ZONING CHANGE REVIEW SHEET

CASE: C14-2023-0063

ADDRESS: 6121 and 6121 1/2 North IH-35

From: Nathan Aubert, P.E.
To: Santiago Araque, P.E., PTOE
Date: July 21, 2023
Subject: 6121 IH-35 – Zoning Transportation Analysis (C14-2023-0063)

Figure 1. Site Location

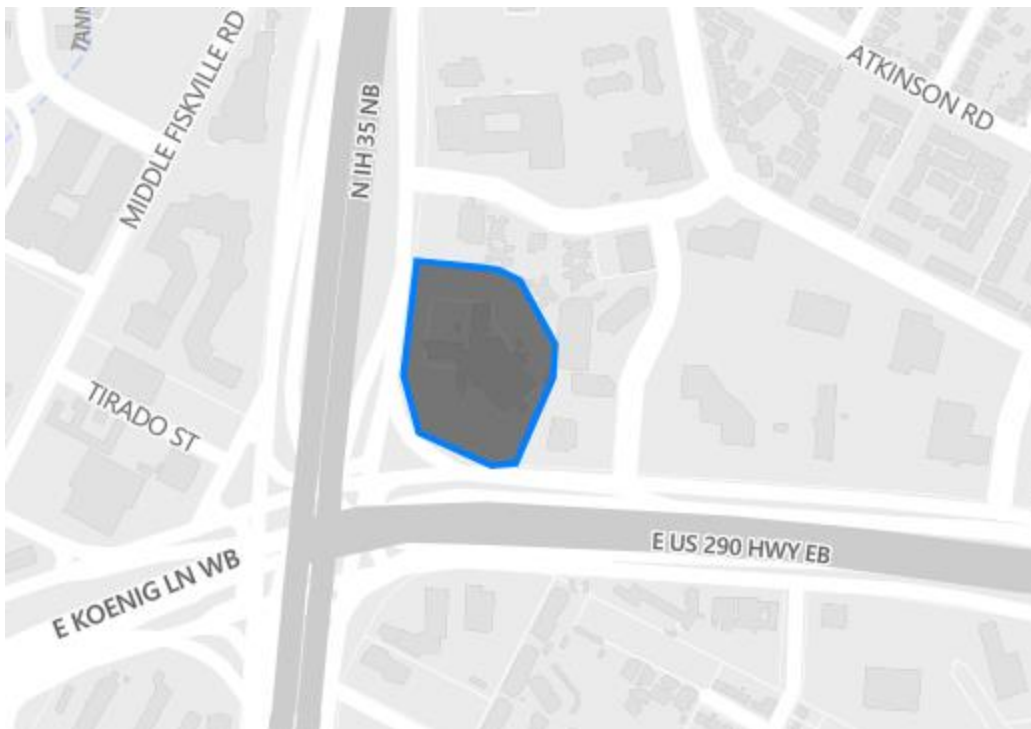
The Transportation Development Services (TDS) Division has reviewed the April 28, 2023 “6121 IH-35 Zoning Transportation Analysis”, prepared by Kimley-Horn. The proposal is for 1,000 (max) high-rise multifamily dwelling units, 40,000 square feet of retail, and 298 hotel rooms. The site is located on the northeast corner of IH-35 NB Frontage Road (NBFR) and US 290 Westbound Frontage Road (WBFR) as depicted on Figure 1 below.

Site access will consist of three right-in, right-out driveways: two along IH-35 NBFR, and one on US 290 WBFR. The development is anticipated to be constructed in one phase to be completed in 2028.

1. Provide no more than two driveways proposed along US 290 WBFR and IH 35 NBFR, replacing the existing driveways. Both driveways will operate as right-in, right-out. Final approval will be given by TxDOT as the site is directly accessing TxDOT roadways.
